UNITED STATES DEPARTMENT OF THE INTERIOR BUREAU OF LAND MANAGEMENT

1. Type of Well ☑ Oil Well ☐ Gag V	Vell Other		8. W	Vell Name and No. der Federal 28 #	1H	
2. Name of Operator ConocoPhillips Company			9. A 30-	PI Well No. 025-40261		
3a. Address P.o. Box 51810 Midland, Tx 79710		3b. Phone No. (include area code) 432-688-6943		Field and Pool or Educated Bone Spring

CONDITIONS OF APPROVAL

ConocoPhillips Company NM-27508 Wilder Federal 28 #1H 30-025-40261 NENE Section 28, T. 26 S., R 32 E., NMPM Lea County, New Mexico

COPPER STATE RUBBER VISUAL INSPECTION / HYDROSTATIC TEST REPORT

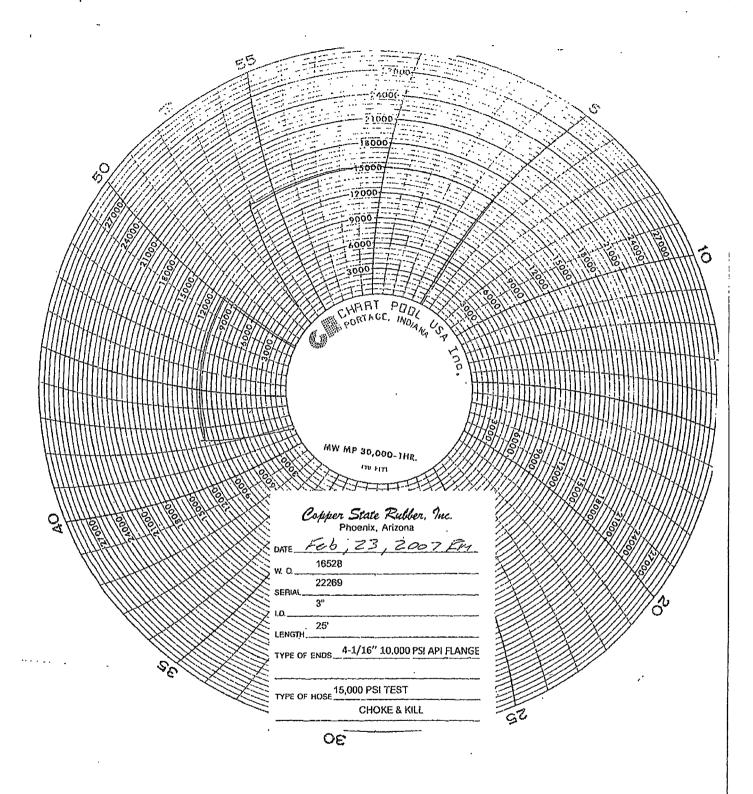
- 1. Variance approved to use flex line with Serial #22269 from BOP to choke manifold. Check condition of 3" flexible line from BOP to choke manifold, replace if exterior is damaged or if line fails test. Line to be as straight as possible with no hard bends and is to be anchored according to Manufacturer's requirements. Anchor requirements to be onsite for review. If the BLM inspector questions the straightness of the hose, a BLM engineer will be contacted and will review in the field or via picture supplied by inspector to determine if changes are required (operator shall expect delays if this occurs).
- 2. Original COA still apply for BOP/BOPE testing requirements
